## AIRWORTHINESS DIRECTIVE

No. 2020-FATA-01020A-11

Applicability - RRJ-95 aircraft

**TECHNICAL DECISION RRJ0000-OR-470-4701**

Pic.1

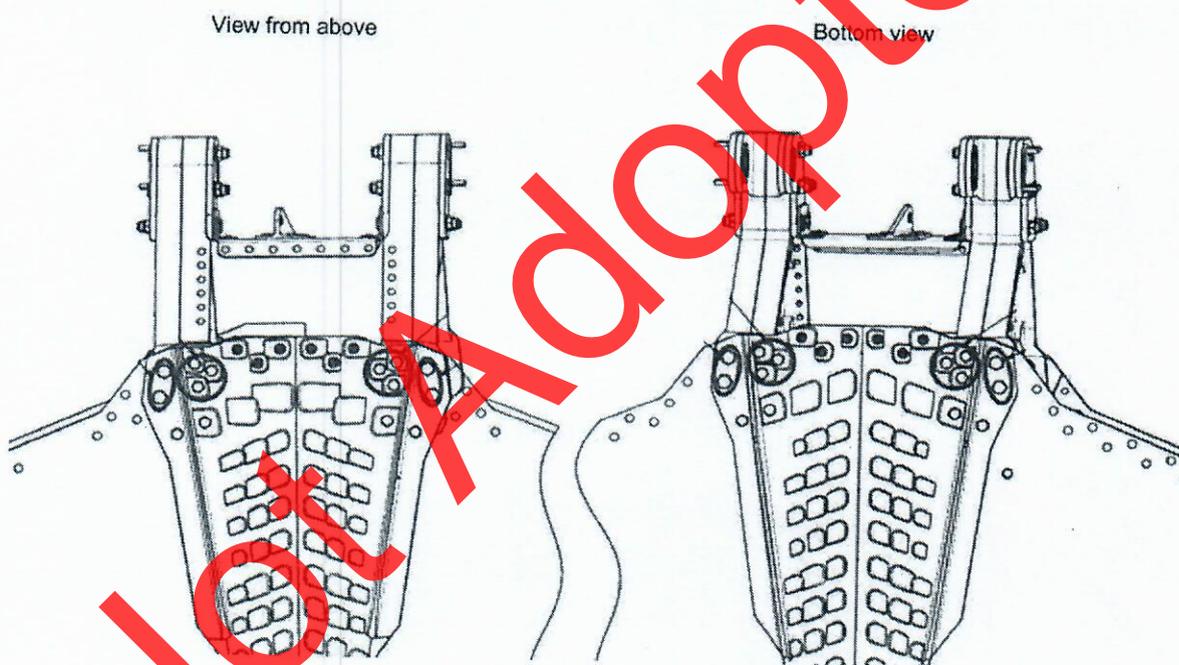
During maintenance of aircraft RRJ-95 fleet it was detected the damages of the bolts 8-28-И-ОCT 1 31138-80 of the stabilizer setting mechanism (further – SSM) attach bracket. The possible root cause of the mentioned bolt damages are assembly stresses, due to a design flaw: on the damaged bolts there is a wedge-shaped gap between the fasteners and the surfaces of the mating parts.

1. At nearest periodic maintenance with minimum multiples: 750 FH and multiples to perform one-time inspection of the SSM attach bracket bolts iaw AMM Task 55-16-00-220-802 «Detailed Inspection of the SSM Attach Bracket and the Horizontal Stabilizer Front Spar» on aircraft RRJ-95 with operating cycles more than 1000 FC (See Pic.1);
2. The results of completion the cl.1 of this Airworthiness Directive to be sent to the address of Situations operative center of PJSC Corporation IRKUT [customercare@ssj.irkut.com](mailto:customercare@ssj.irkut.com);
3. In case of discrepancies absence during performing action related to cl.1 of the current Airworthiness Directive to continue the aircraft RRJ-95 operation with further periodic inspection of the SSM attach bracket bolts iaw AMM Task 55-

16-00-220-802 «Detailed Inspection of the SSM Attach Bracket and the Horizontal Stabilizer Front Spar» with interval 750 FH/500FC (what comes first);

4. In case of discrepancies detection during performing action related to cl.1 to follow iaw Type Certificate Holder recommendations.
5. To guide by requirements of current Technical Decision till Technical Documentation Revision or other aircraft RRJ-95 Type Certificate Holder notification.
